APPLICATION NO.	FILING DATE	FIRST NAMED INVENTOR	ATTORNEY DOCKET NO.	CONFIRMATION NO.
10/796,703	03/09/2004	Stephen S. Hancock	TIR 2904, 2905	2888

Office Action Summary

10/796,703

Figure 1 Beehler annotated Fig. 4.

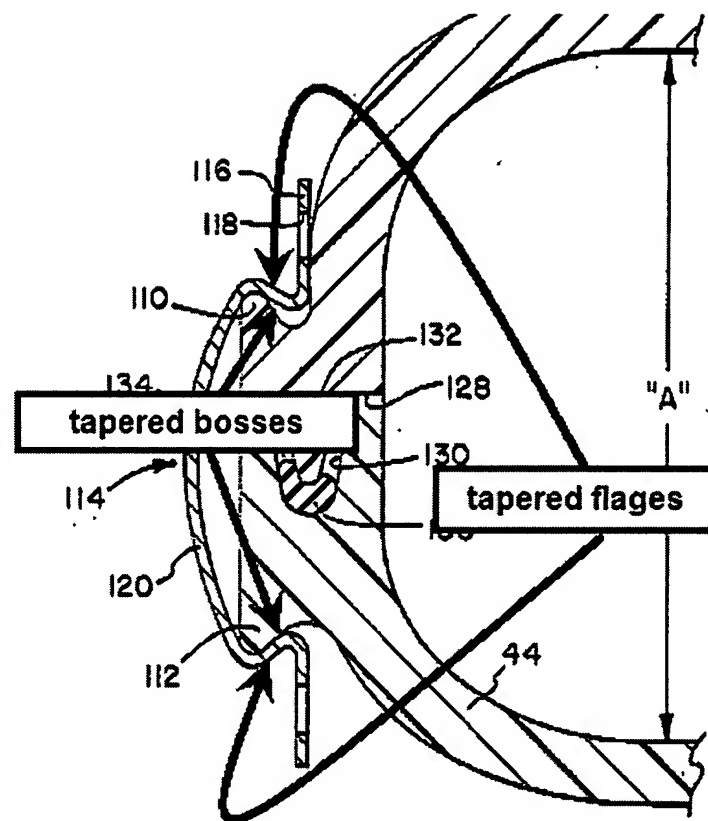
The bosses are tapered toward each other and the clips include opposed tapered flanges engagable with respective one of the bosses for registering the clips with the bosses in a wedge configuration (see Figure 1 below).

The bosses are tapered toward each other and the clips include opposed tapered flanges engagable with respective one of the bosses for registering the clips with the bosses in a wedge configuration (see Figure 1 above).

The bosses are tapered toward each other and the clip includes opposed tapered flanges engagable with respective ones of the bosses for registering the clip with the bosses in a wedged condition (see Figure 1 above).
